**SYDNEY WATER
BUILDING PLAN APPROVED
ASSET NOT AFFECTED**

Dolphin No: D12/3-15243

Building/Structure Description: new residence

Building Plan No: 497A-13

SITE PLAN & STORMWATER CONCEPT PLAN

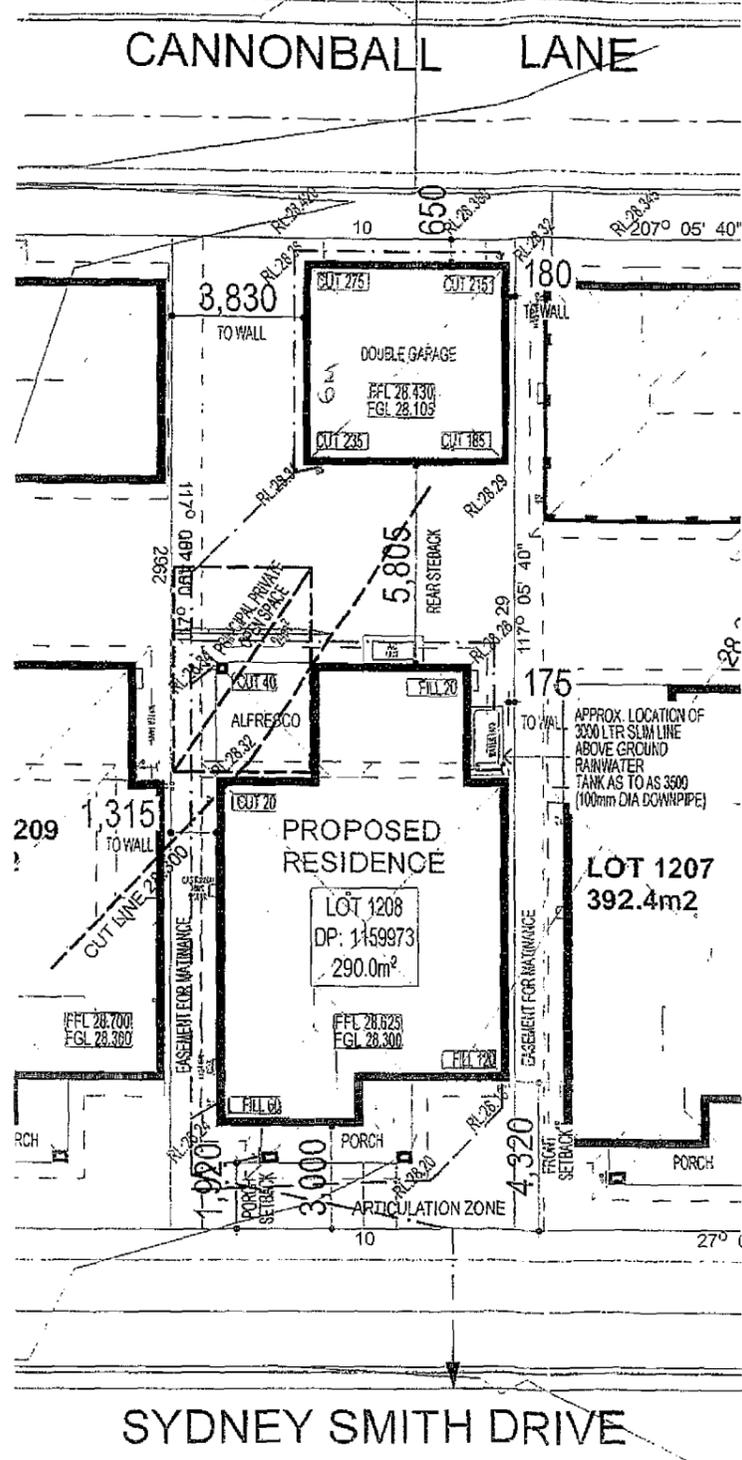
Accredited Supplier to SYDNEY WATER
BUILDING PLAN APPROVED
ASSET NOT AFFECTED
 Ref No: ~~2012/3-15243~~ Date: ~~4/6/13~~

1. Service Location Report / Work As Constructed plan reveals the building/structure is outside the Zone of Influence. No special precautions required.
